Memorandum

Message Ref: Response to request for further information

Project No: BM219727/RC225180

Please find below KeaX's response to your request for further information dated 28th April 2022.

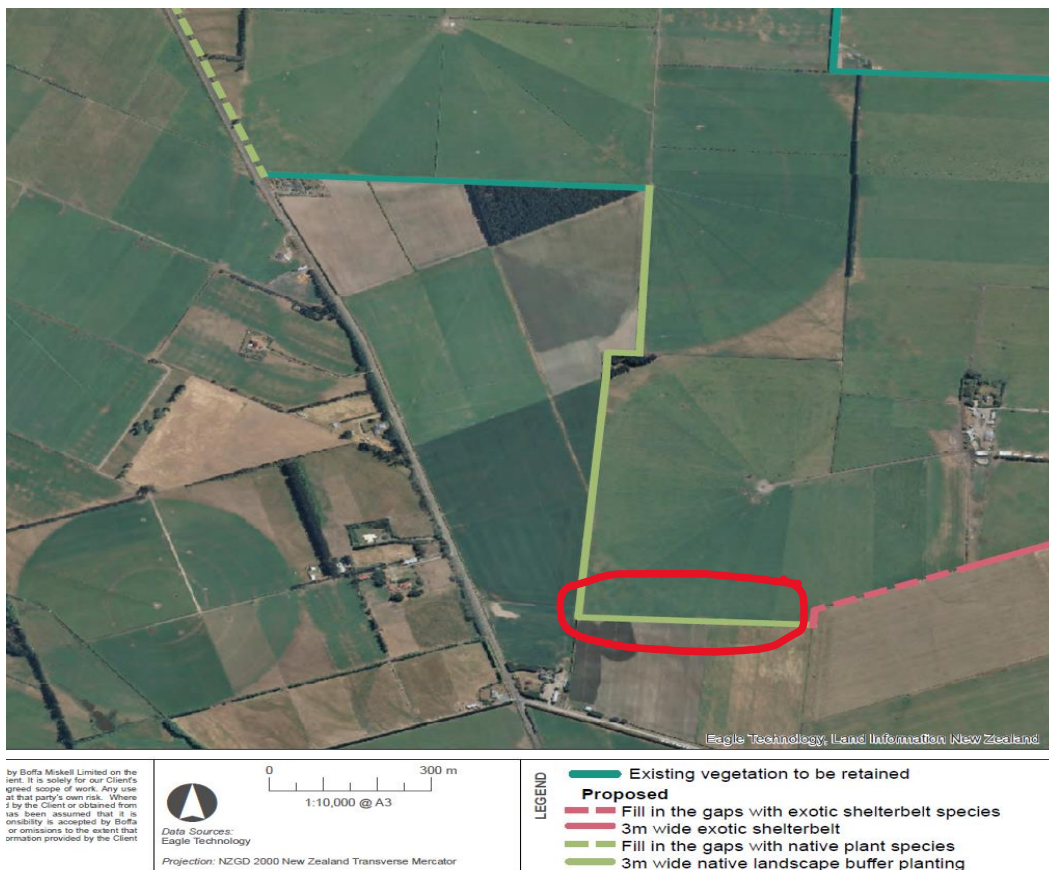
- b. *Page 15 of the Landscape and Visual Assessment makes reference to that area of the site which retreats inland from Branch Drain Road as being filled with exotic shelterbelt species and planted in double staggered rows to provide screening for Stage 2. Please confirm what screening/area shown on Figure 3 of the landscape assessment is being referred to as the legend in Figure 3 appears to suggest native planting is proposed, if I have the correct area.*

The AEE states that 'the existing Site boundary shelterbelts and landscaping will be retained, except for the shared boundary with 180 Grahams Road. Along this boundary, the existing exotic shelterbelt plantings will be removed and replaced with a 3m wide native buffer planting.' This is correct and Figure 3 in the LVEA is correct – the area to be replanted is highlight below.
